Preliminary Evaluation

Revision of Best Available Control Technology Determination  
and  
Permit to Construct

Lonestar Pennsuco, Inc.  
Dade County

Federal Permit Number  
PSD-FL-050

Figure I

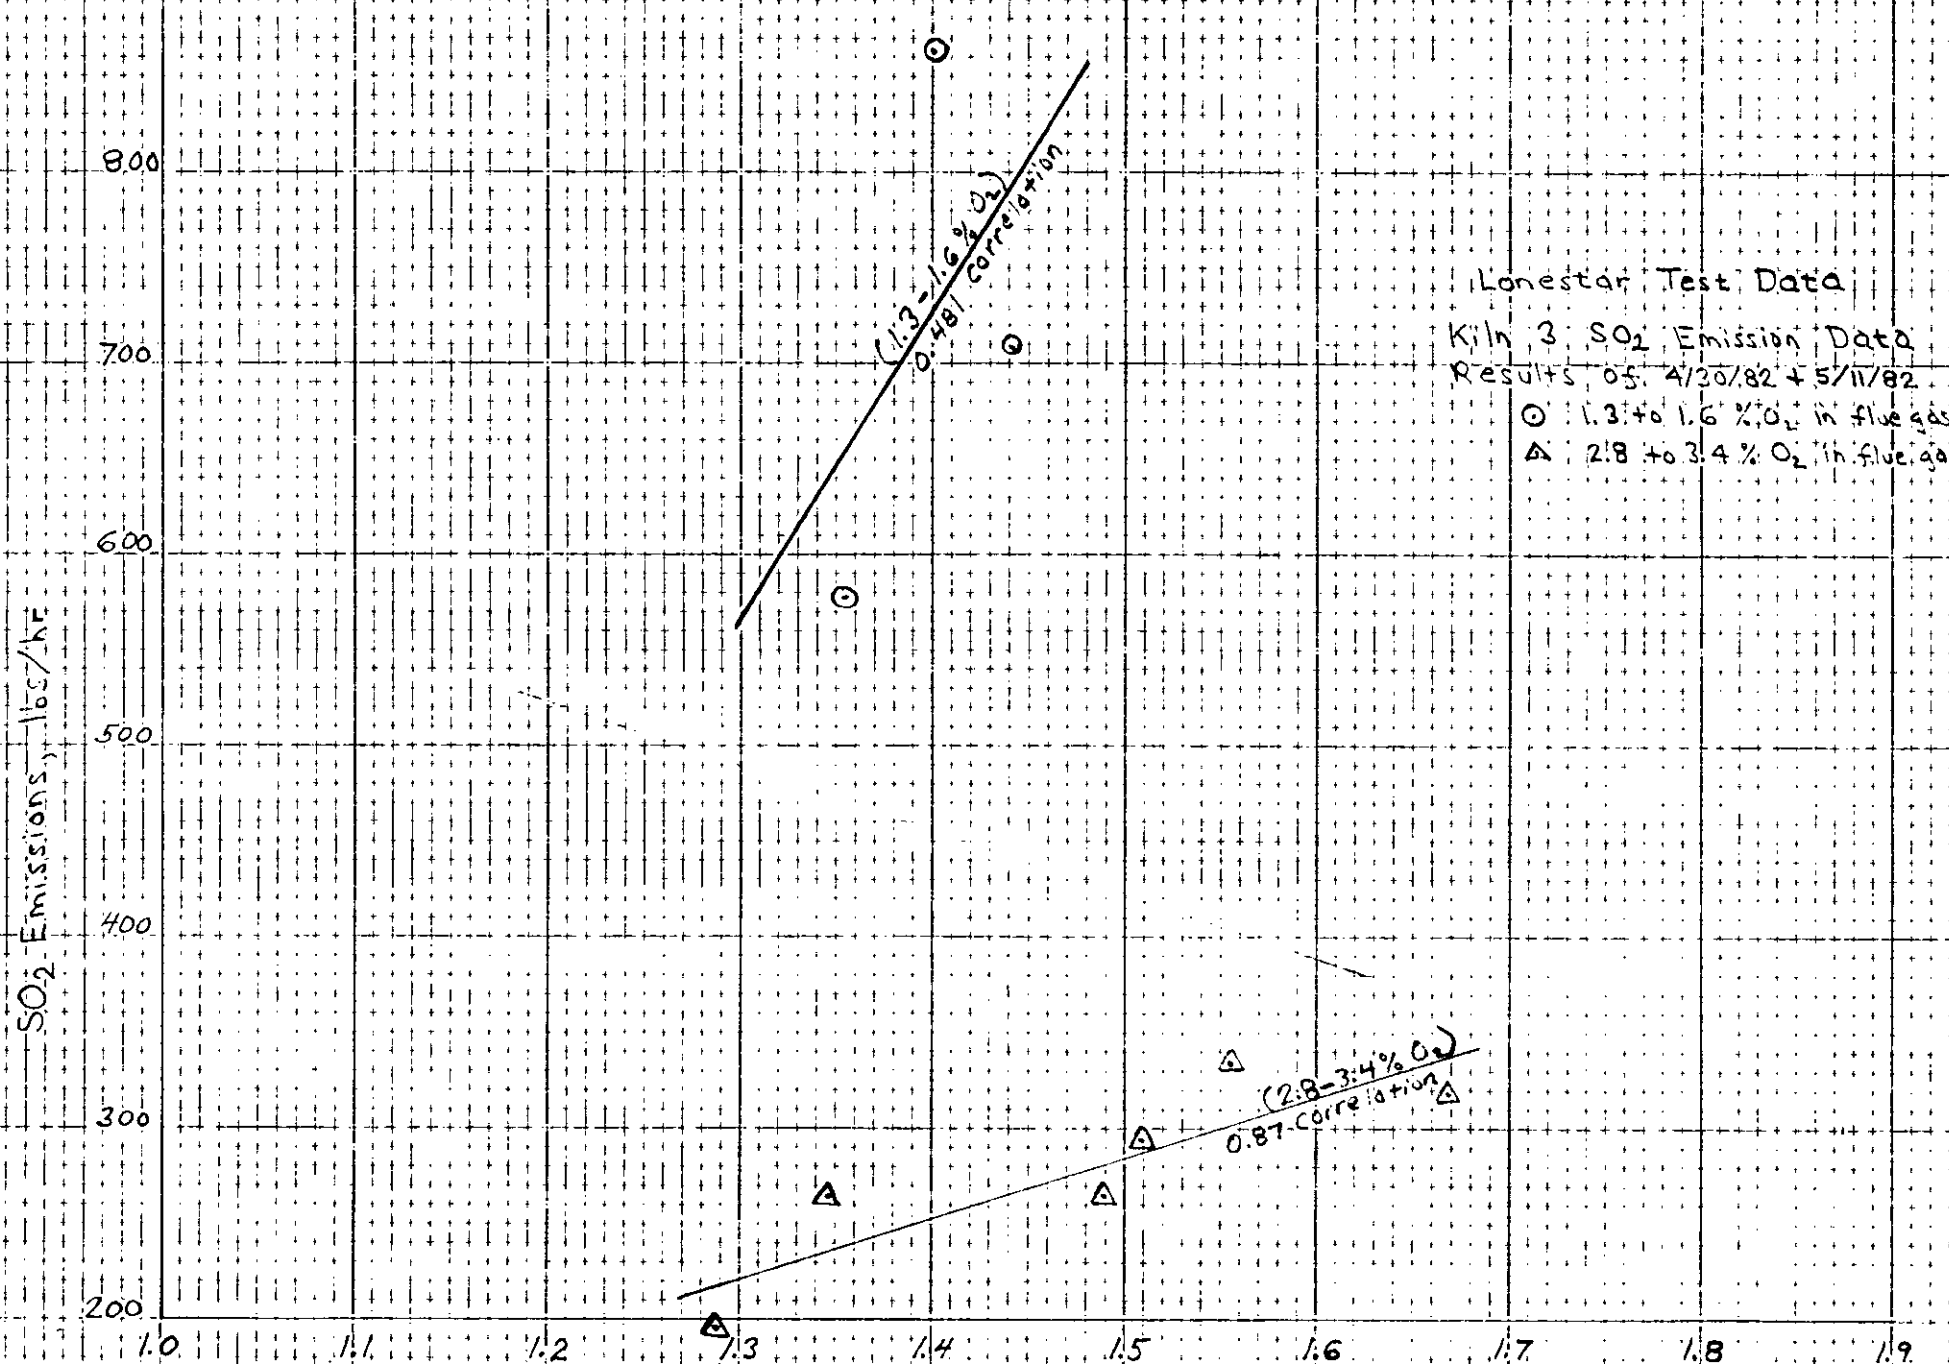
Kiln No. 3 has been converted to coal fuel and actual test data shows the sulfur dioxide removal is less than 90 percent. The applicant has studied the latest test data and now believe the systems will obtain only 75 to 85 percent sulfur dioxide removal.

Calculations using the maximum feed and coal inputs to the kiln listed in the original application for permit to construct, the maximum sulfur content in the feed from Lonestar's June 13, 1983 letter, and a sulfur removal of 75 percent by the system shows the kilns would have to burn coal with no more than 0.75 percent sulfur for kilns 1 and 2 and 1.0 percent for kiln 3 to meet the sulfur dioxide emission standards now being requested. (See Table I and Figure 1) This is low sulfur fuel. As these emissions cause no
